COMMUNITY DEVELOPMENT DEPARTMENT
501 Delta Avenue ♦ Marysville, WA 98270 ♦ (360) 363-8000

Re: PA23-026 – Cornelius Lacey PRD – Technical Review 1

SUBJECT: PA 23-026 – Cornelius Lacey PRD

RE: Cornelius and Lacey Property, File# PA23-026
67-lot Planned Residential Development (PRD).
8310 E Sunnyside School Road & Parcel #'s 0059070016102, 0059070017700, and
059070018601

Figure 1. Tall retaining walls must be terraced with landscaping as depicted below.

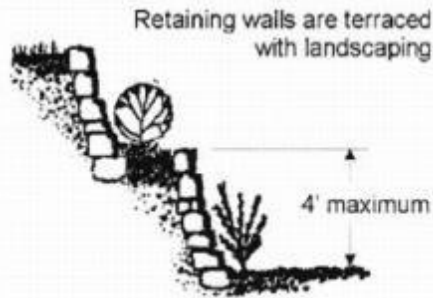
1. [MMC 22G.090.560](#) requires that the design and development of subdivisions attempt to preserve the topography of the site by selection and location of buildings which fit the natural slope of the land. As proposed, with multiple areas/lots proposed to have retaining walls ranging from 3 to over 8 feet in height, it does not appear the proposal meets this requirement. Walls proposed strictly to obtain flat lots will not be permitted. Other alternatives (i.e. tuck-under house plans) should be implemented to reduce/eliminate wall height.
2. Pursuant to [MMC 22D.050.030\(4\)\(e\)](#), if retaining walls taller than four feet are used, and are visible from the street or adjacent property, they shall be terraced so that no individual segment is taller than four feet. Any walls ultimately permitted exceeding 4 feet shall comply with these requirements.
